Latrine for Secretariat clerks
on Stone House, Cotacamund

TECHNICAL NOTE.

Name of work Latrine for Secretariat
Clarks on Stone House Hill, Cotacamund
Amount of estimate Rs 1080

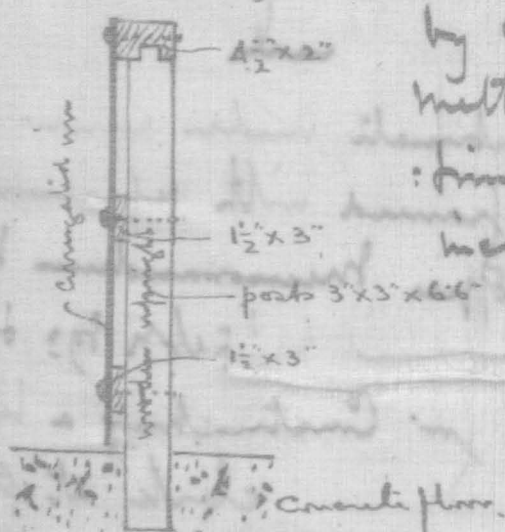
congregated in partition walls are proposed to be fitted on wooden sleepers & not embedded in concrete as shown on plan, moreover these sleepers are not secured to the floor by any anchor bolts etc. The best method appears to be to build in the wooden uprights in the concrete floor & provide wooden battens as per sketch in order to bolt the congregated iron thus:-

by adopting this method the estimate will be increased by Rs. 25.
